UNITED STATES PATENT AND TRADEMARK OFFICE

10/747,617

Office Action Summary	Application No. 10/747,617	Applicant(s) BOOGAARTS ET AL.	
	Examiner Samuel A. Turner	Art Unit 2877

DETAILED ACTION

FIG. 3

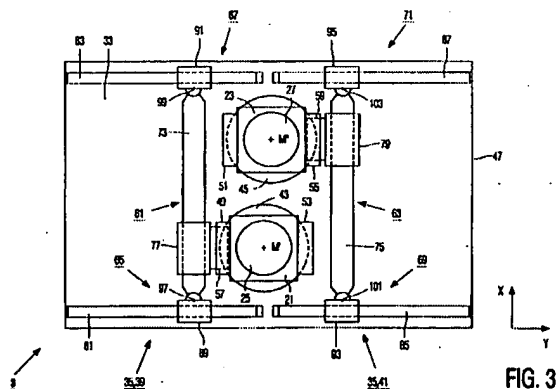
a first exposure system having at least one movable part(figure 3), said at least one movable part being located within said housing, said first exposure system including:

As to claim 4, wherein said additional movable part comprises at least one of a second exposure stage that has at least a movable second substrate holder and a measuring stage for measuring a property of a substrate that has at least one of a movable substrate measuring table and a movable measuring unit(23, figure 3; page 6, lines 8-30).

FIG. 1

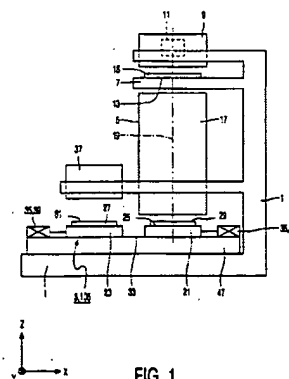
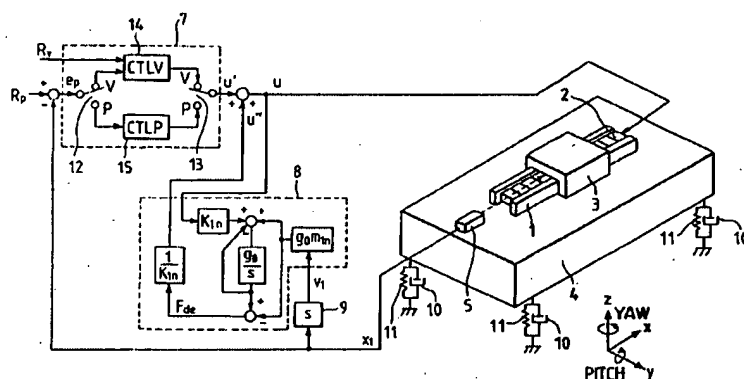
Sato et al teach a precision positioning apparatus for an exposure apparatus including a means for correcting the disturbance of posture or vibration based on the guide mechanism. See figure 1 and column 8, lines 40-63.

Sato et al teach a precision positioning apparatus for an exposure apparatus including a means for correcting the disturbance of posture or vibration based on the guide mechanism. See figure 1 and column 8, lines 40-63.
